To: Historic Landmark Commission

From: Kelsey Lindquist, Senior Planner

Date: March 5, 2020

Re: Ensign Floral Building - Alteration to a Contributing Structure

**Approved Elevation**

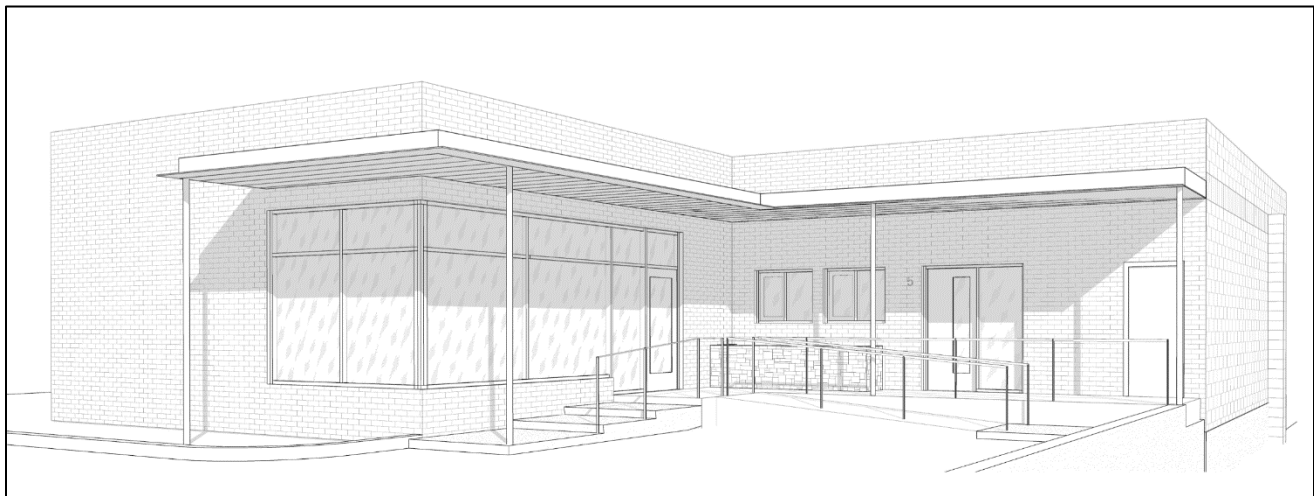
The approved Ensign Floral west and south elevations included the installation of a canopy that was designed to mimic the original/historic canopy and was to cantilever across the primary elevation.

The applicant is requesting to install 4 circular columns along the west and south elevation to aid in distributing the weight of the canopy. The applicant provided an

“Our proposal is to add four columns to the exterior side of the canopy. By eliminate most – but not all - of the cantilever with columns on the outside of the building, we can avoid having to penetrate the original wall and bond beam and avoid the connection to the double tees altogether. We have proposed small round columns similar to the existing column on the interior of the Ensign Building at the southwest corner of the large storefront window. One column would be placed at the north end of the canopy, in line with the edge of the front window on the west façade. Another would be placed at the south end of the canopy, at the south edge of the west façade. Between these two columns, the building and canopy make a zig-zag with two 90 degree turns, resulting in an outside corner at the southwestern-most point over the stairs leading to the front door, and an interior corner near the front door. Rather than placing the columns at the corners, the design and engineering team has worked to place the interior columns away from the corners, allowing these corner to retain an appearance of cantilevering at these key visual moments. The canopy increase a small amount so that the columns could land on the edges of the walkways below.”

The four columns are circular and approximately 4 inches in size. The canopy is proposed to increase 12 inches so that the columns connect to the beam and not the edge of the canopy. The new depth of the canopy is approximately 6’4.5”.

Planning Staff recommends that the Historic Landmark Commission approve the request for a Certificate of Appropriateness for the columns for the Ensign Floral Building.
